R11TA

April 12, 2011

## Starter Cable May Contact Power Steering Hose

**Models Affected: 2004 through 2006 Model Year "Vision"**

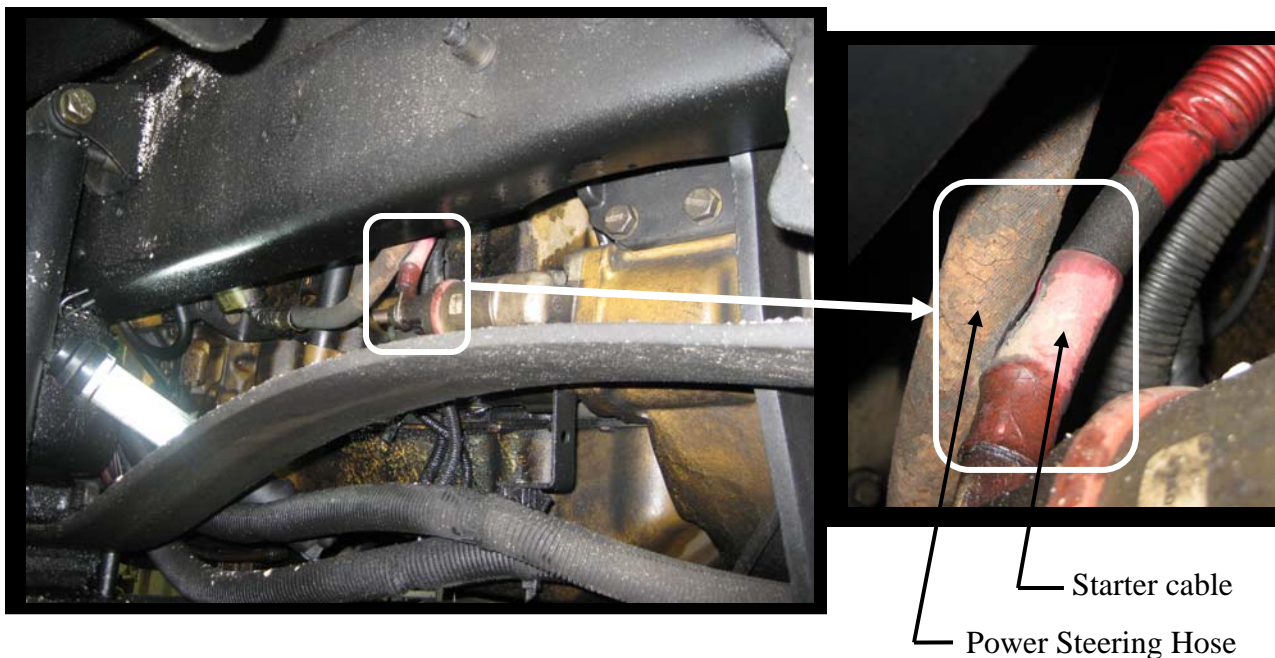
The starter cable may contact and potentially chafe against the steel braided power steering hose thereby creating a direct short which could result in a fire.

1. Park the bus on a level surface, apply parking brake, and remove ignition key and chock wheels.
2. Disconnect Batteries: Note when disconnecting the batteries, remove the Negative cable first.
3. On lower left side (driver's) of engine; inspect the positive starter cable and power steering hose for possible contact as shown below.

Inspect for proper clearance between the starter cable and the power steering hose. If insufficient clearance is found, install a clamp to prevent further contact. Any damaged power steering hoses or starter cables must be replaced.

Install dual swivel saddle mount and cable ties.

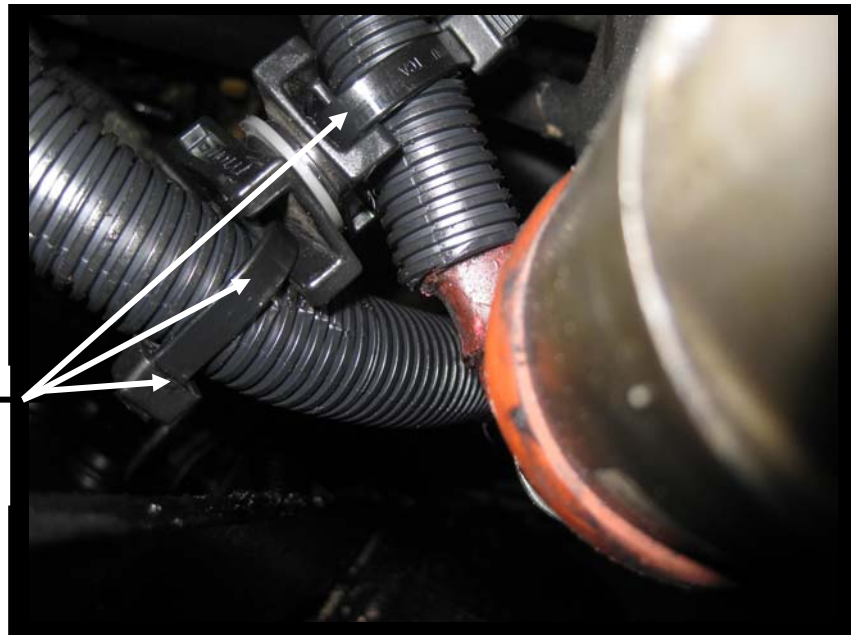
- 4. If the starter cable has contacted the power steering hose, separate and inspect both for any possible damage. If either has been damaged, contact Blue Bird Recall Administrator for a replacement.
- 5. If there is no contact and a minimum of one (1) inch clearance between the starter cable and power steering hose, no further action is required.
- 6. If there less than one (1) inch clearance, install a dual swivel saddle mount and two cables ties between the power steering hose and starter cable and secure with two cable ties.
